Appendix 1.3: Scoping Opinion

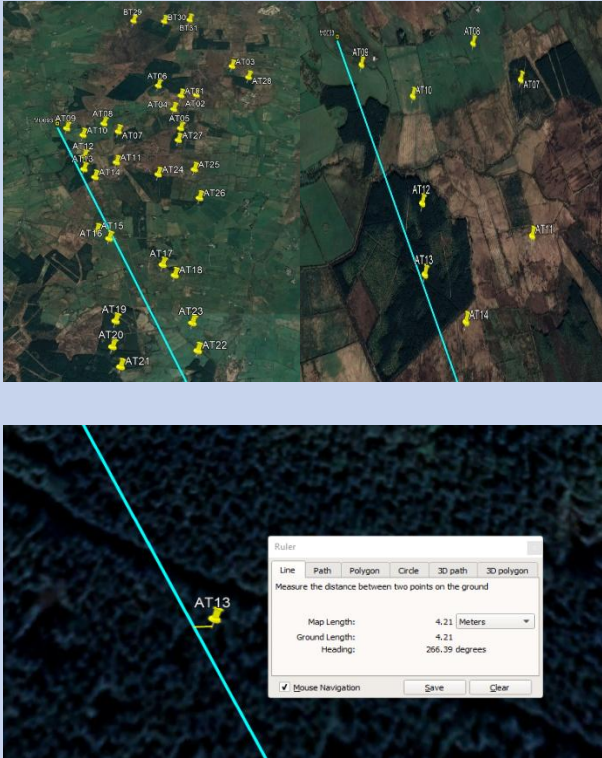
Consultee Organisation	Response Received	Implications for the EIA/Design	EIAR Chapter/Section where comments have been addressed												
Telecommunications															
Broadcasting Authority of Ireland	Response received 06/03/2023 <i>"The BAI does not perform an in-depth analysis of wind turbines on FM networks. However, we are not aware of any issues from existing windfarms into existing FM networks. Also, the proposed windfarms are not located close to any existing or planned FM transmission sites".</i>	N/A	N/A												
Eir Limited	No Response 28/09/23														
ENET	<p>Response received 15/03/2023 <i>"We have only link possibly affected":</i></p> <table border="1" data-bbox="506 743 1509 1019"> <thead> <tr> <th>Link name</th> <th>A-End Coordinates</th> <th>A-End Dish Height</th> <th>B-End Coordinates</th> <th>B-End Dish Height</th> <th>Frequency</th> </tr> </thead> <tbody> <tr> <td>TC Schantra – S N Beanchair</td> <td>54.203520 -9.4350090</td> <td>21m</td> <td>54.264328 -9.226600</td> <td>6m</td> <td>13GHz</td> </tr> </tbody> </table> <p><u>JOD Response</u> <i>"On double checking links in the surrounding area of the Proposed Tirawley Windfarm, one of our Turbines AT06 is close to the below link mentioned. Please see attached image. The link passes the turbines base at a distance of 73.60m. The turbines blades measure at 52.5m, giving a setback distance of 21.1m from the links path. Can you confirm if this setback distance is enough to avoid any interference with the mentioned link TC Shanetra - S N BEANNCHAIR".</i></p>	Link name	A-End Coordinates	A-End Dish Height	B-End Coordinates	B-End Dish Height	Frequency	TC Schantra – S N Beanchair	54.203520 -9.4350090	21m	54.264328 -9.226600	6m	13GHz	N/A	Telecommunication s discussed in Section 14.6 of Chapter 13 Material Assets & Other Issues
Link name	A-End Coordinates	A-End Dish Height	B-End Coordinates	B-End Dish Height	Frequency										
TC Schantra – S N Beanchair	54.203520 -9.4350090	21m	54.264328 -9.226600	6m	13GHz

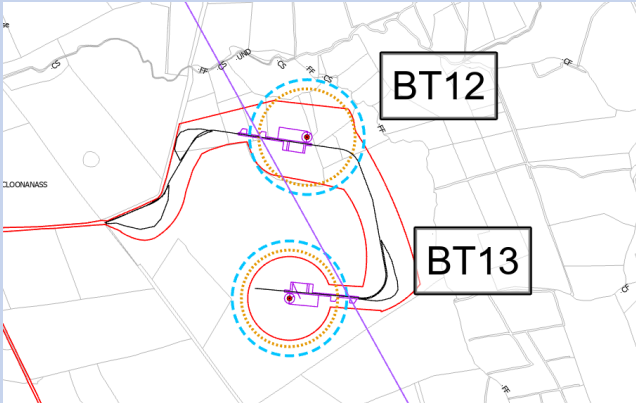
Consultee Organisation	Response Received	Implications for the EIA/Design	EIAR Chapter/Section where comments have been addressed
	 <p><u>ENET Response</u> <i>"We should be just about ok based on my calculations below"</i></p>

Consultee Organisation	Response Received	Implications for the EIA/Design	EIAR Chapter/Section where comments have been addressed																																				
	<p><u>JOD Response</u> “We have adjusted AT01 recently to avoid Link Name/ID20109 (Purple Line seen Below). Due to space constraints, it could only be adjusted so much where the link no longer passes through the centre mass of the turbine (red dot). However, it is still within the rotor diameter of the turbine (orange circle) i.e. the area within the turbines blade area. Can you confirm if this will interfere with the link”.</p>  <p><u>Three Response</u> “We are looking at rerouting our MY0156 site to avoid this development. Can you plot this link below in your system? I think it will route between AT01 and AT02 turbine blades. Also, any chance that you have the coordinates for this whole development in Irish Grid format”.</p>
